DOCUMENT NO. 80SDS4244  
APRIL 1981  
REV. 2

HYDROGEN CONTAINMENT ANALYZER  
QUALIFICATION AND PERFORMANCE  
TEST REPORT

CUSTOMER/PROJECT SCE/SONG 2, 3		PRODUCT NAME CONTAINMENT POST LOCA H <sub>2</sub> MONITORING SYSTEM QUALIFICATION REPORT	
PURCHASE ORDER NO. V4109581	REV. 2	PURCHASE ORDER ITEM(S) NO. 4	QUANTITY 6
<p align="center"><b>SUPPLIER'S CERTIFICATION</b></p> <p>THIS IS TO CERTIFY THAT THE PRODUCTS IDENTIFIED HEREIN HAVE BEEN MANUFACTURED UNDER A CONTROLLED QUALITY ASSURANCE PROGRAM AND ARE IN CONFORMANCE WITH THE PROCUREMENT QUALITY REQUIREMENTS INCLUDING APPLICABLE CODES, STANDARDS AND SPECIFICATIONS AS IDENTIFIED IN THE ABOVE-REFERENCED DOCUMENTS; UNLESS NOTED BELOW. ANY SUPPORTING DOCUMENTATION WILL BE FORWARDED OR RETAINED IN ACCORDANCE WITH PURCHASE ORDER REQUIREMENTS.</p> <p>SIGNED: <u>J.E. Murphy</u> DATE: <u>10-23-80</u>          TITLE: <u>J.E. MURPHY</u> ORGANIZATION: <u>GE-SD</u>  <u>QC PROJECT ENGINEER</u></p> <p>NONCONFORMANCES FROM PROCUREMENT QUALITY REQUIREMENTS:</p> <p>NONE</p> <p>REMARKS/EQUIPMENT SERIAL NUMBERS:</p> <p>DOCUMENT NUMBER 80SDS4244</p> <p align="right">5023-508-17-10-0</p>

Figure 2. Hydrogen Analyzer Electronics Panel

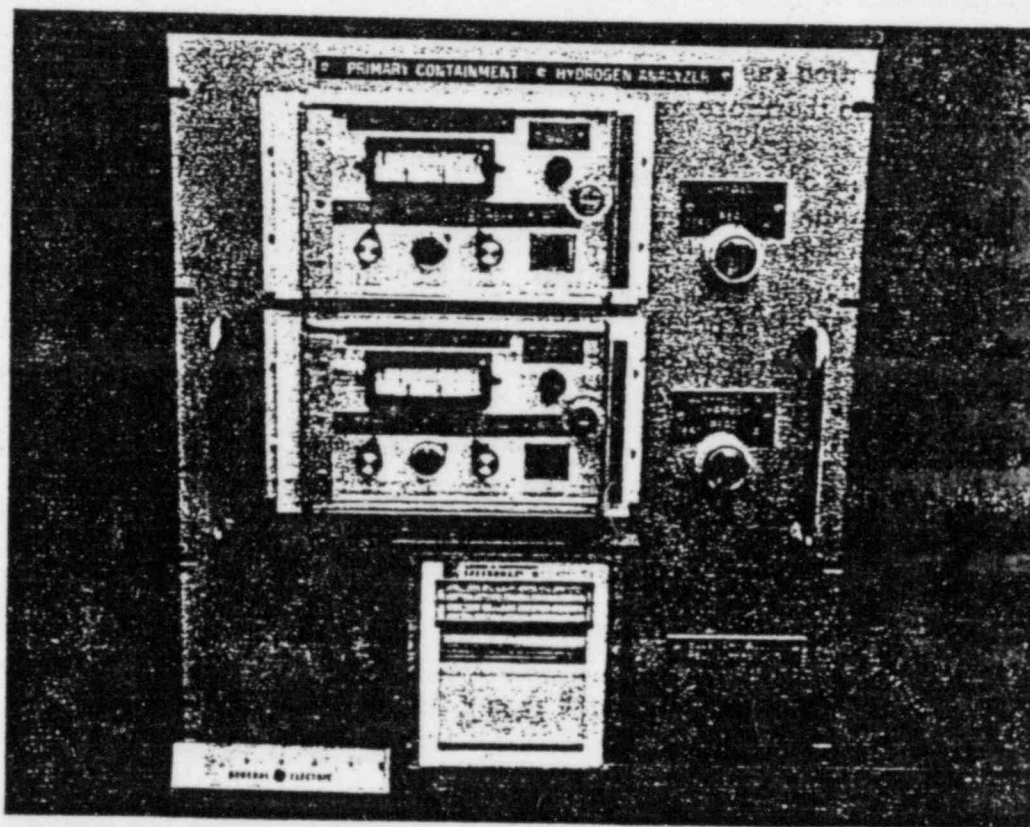
*Not included in Appendix A. It is shown in Figure 2 of Section 1*

Figure 4. Signal Conditioning Assembly

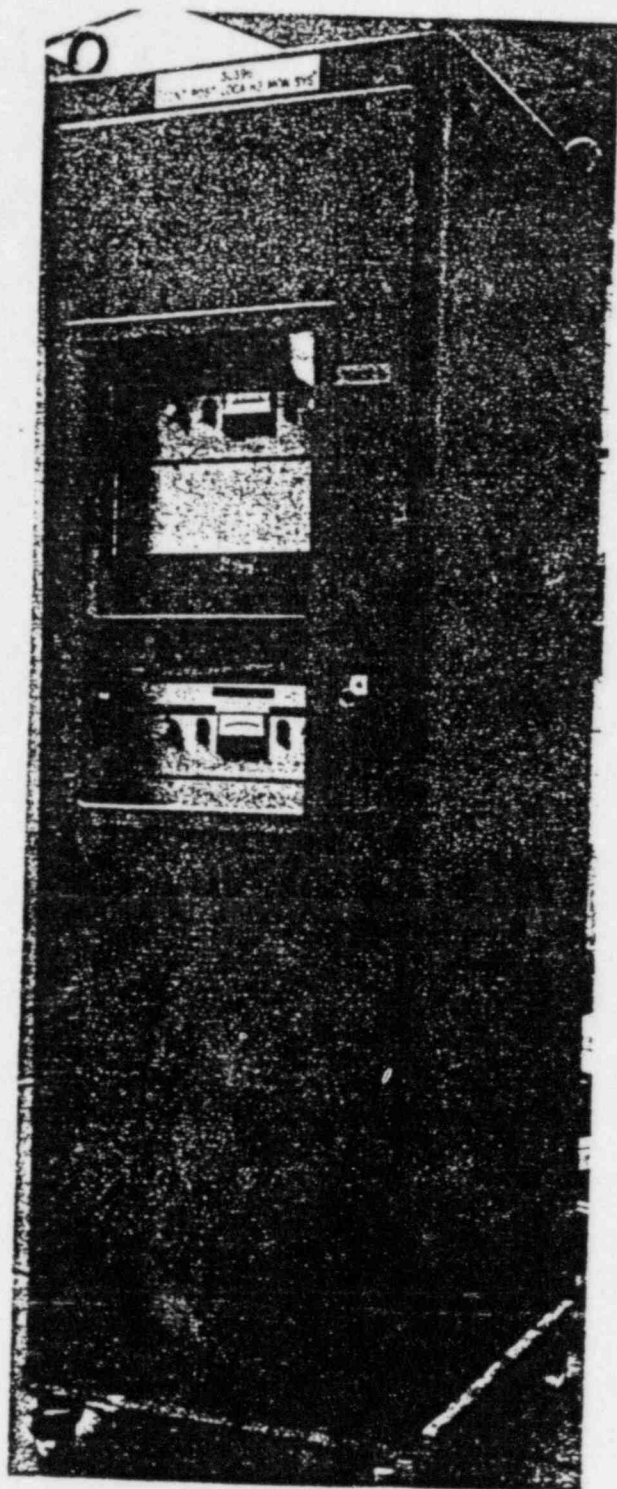
*It is not evident that the system described in A's 1.3.3 and 1.3.4 is that which was supplied to SONGS 2&3. Please clarify.*
